Town of Brookline

PLANNING BOARD

Subject: Reconfigure driveway layout, requiring relief for front yard setback and design of all off-street parking facilities.

Location: 52 Norfolk Road

PROPOSED REVISION

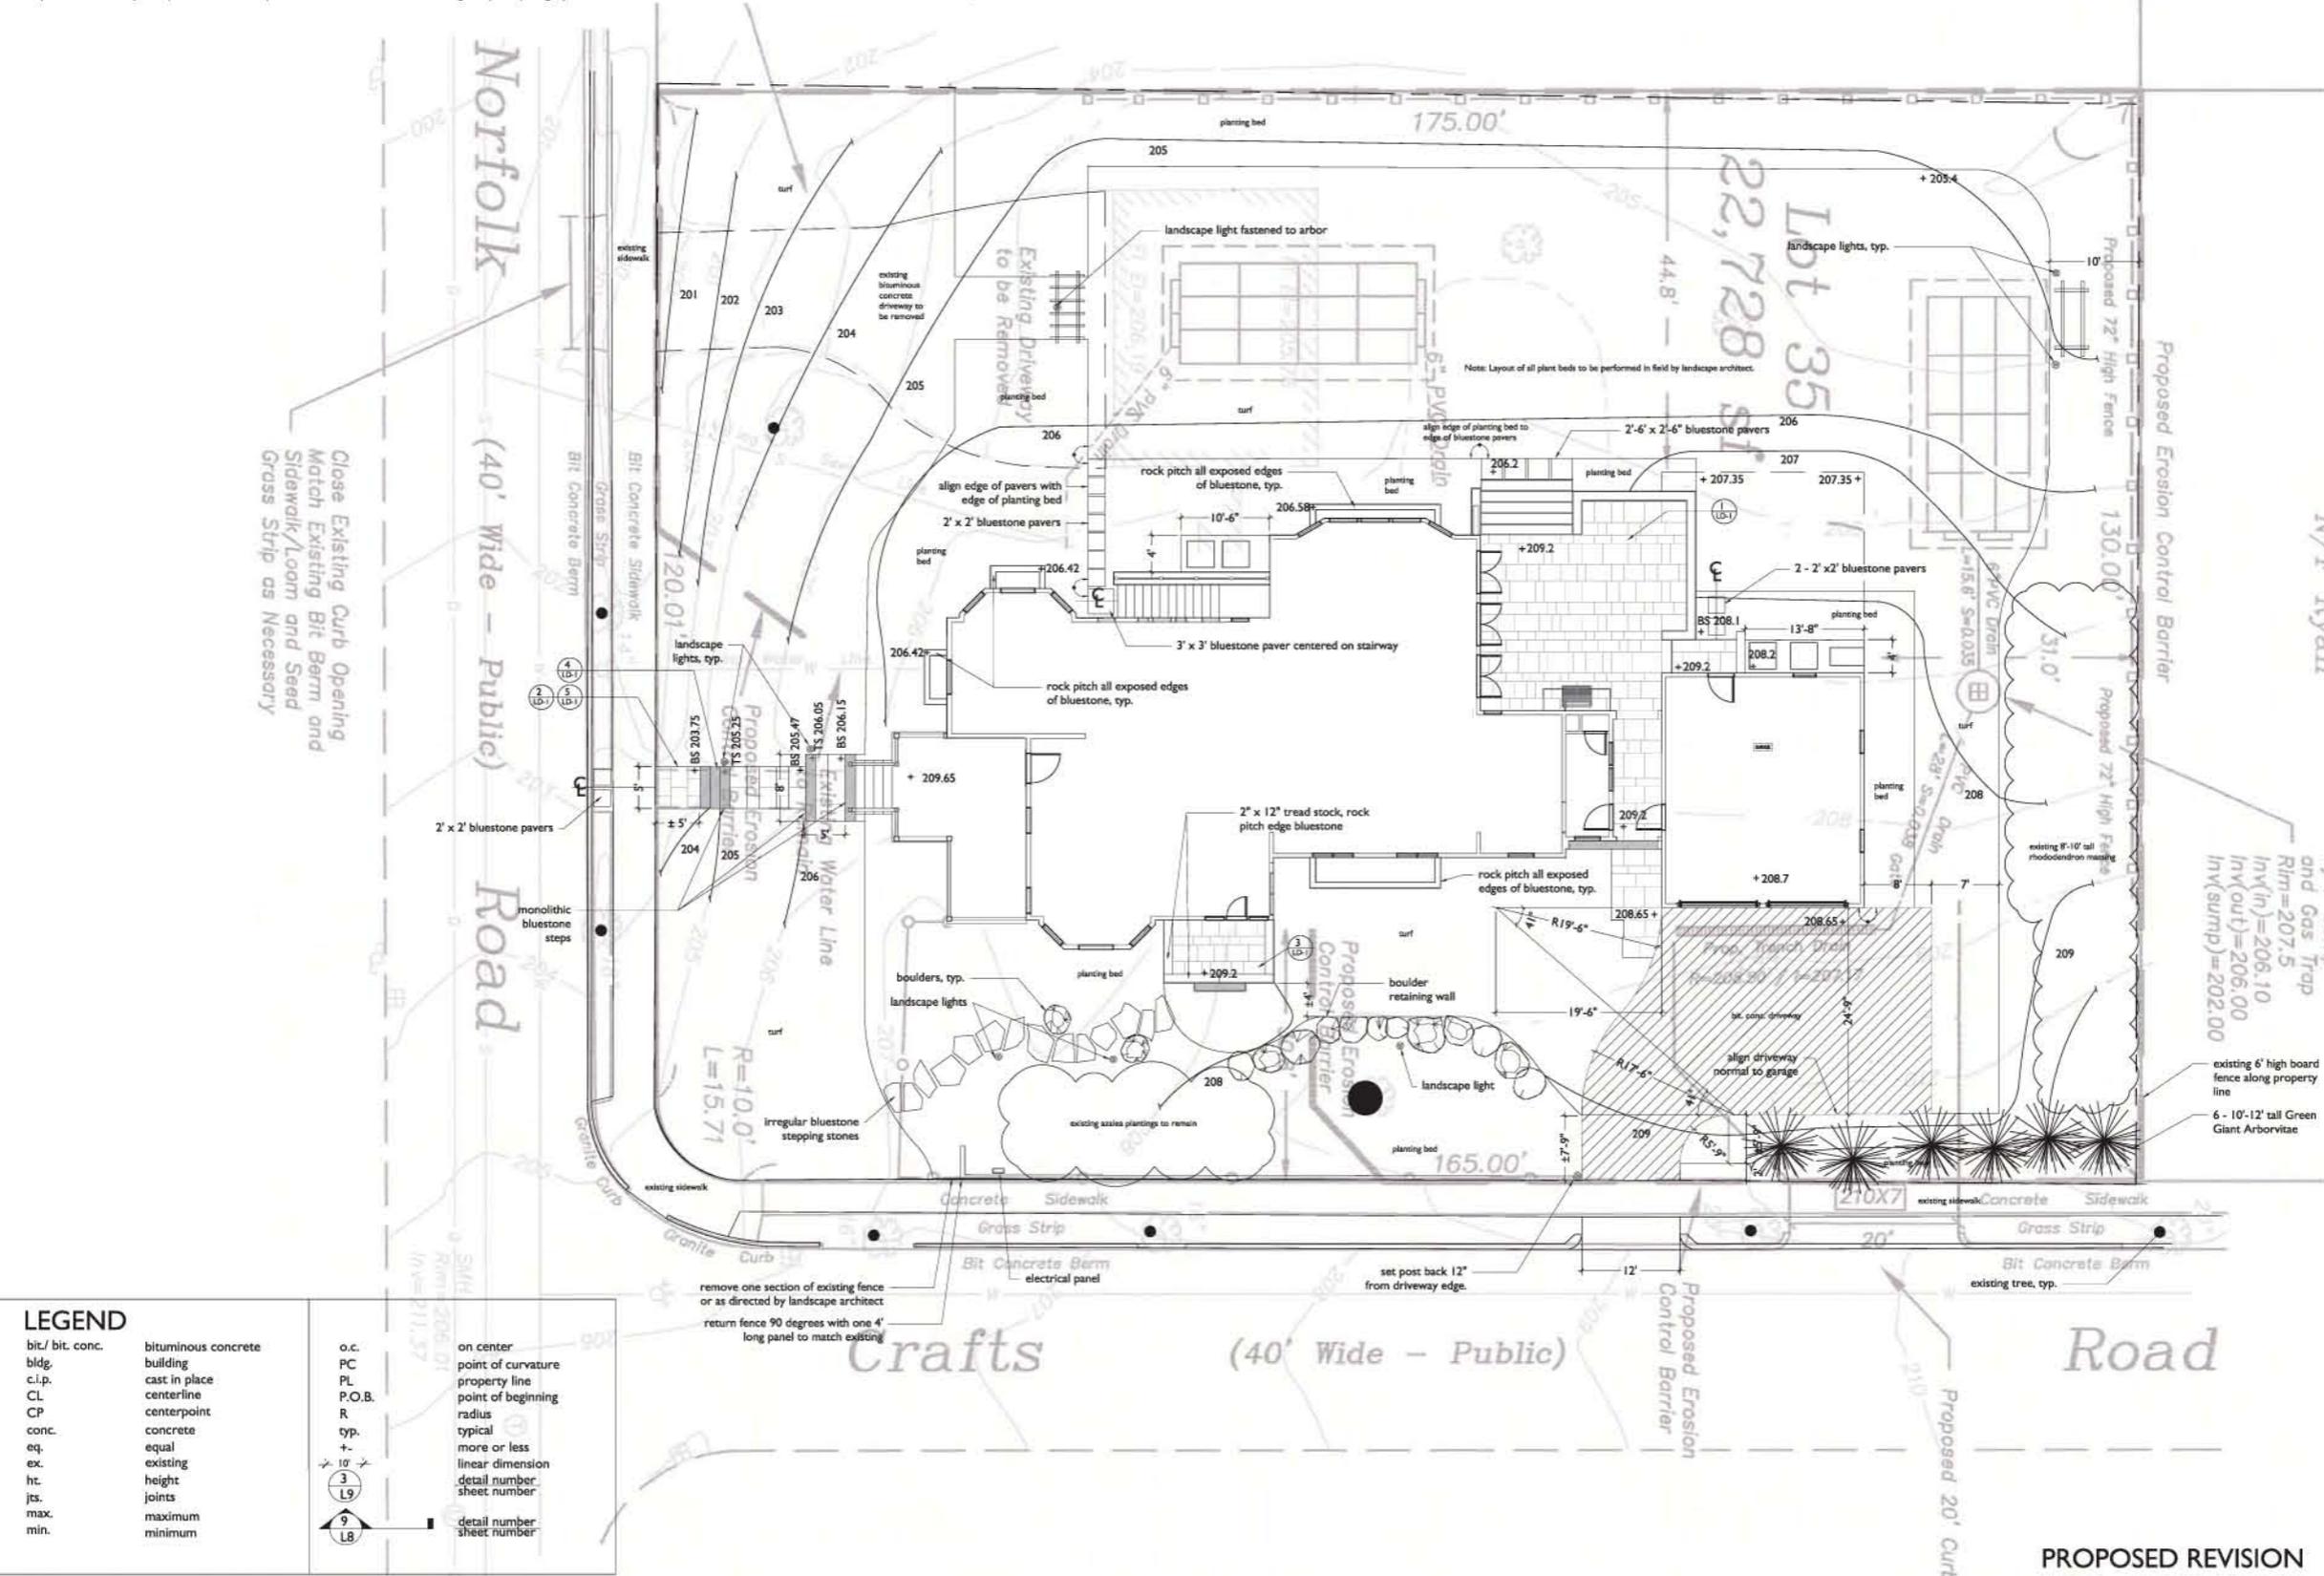
The Planning Board is supportive of the proposed revision. The newly angled parking will not significantly increase nonconformance with setbacks and these new parking spaces will be screened by fencing and landscape features.

Therefore, the Planning Board recommends approval of the site plan submitted by Verne T. Porter, Jr. PLS dated March 7, 2014, and the plans by registered architect Kent Duckham and landscape architect Blair Hines dated June 9, 2014 and revised July 7, 2015, subject to approval the following conditions:

1. Prior to the issuance of a building permit, the applicant shall submit a final site plan showing the reconfigured driveway consistent with architectural/landscaping plans revised July 7, 2015, subject to review and approval by the Assistant Director for Regulatory Planning.

2. Prior to the issuance of a building permit, the applicant shall submit a final landscaping plan indicating all counterbalancing amenities subject to review and approval by the Assistant Director for Regulatory Planning.
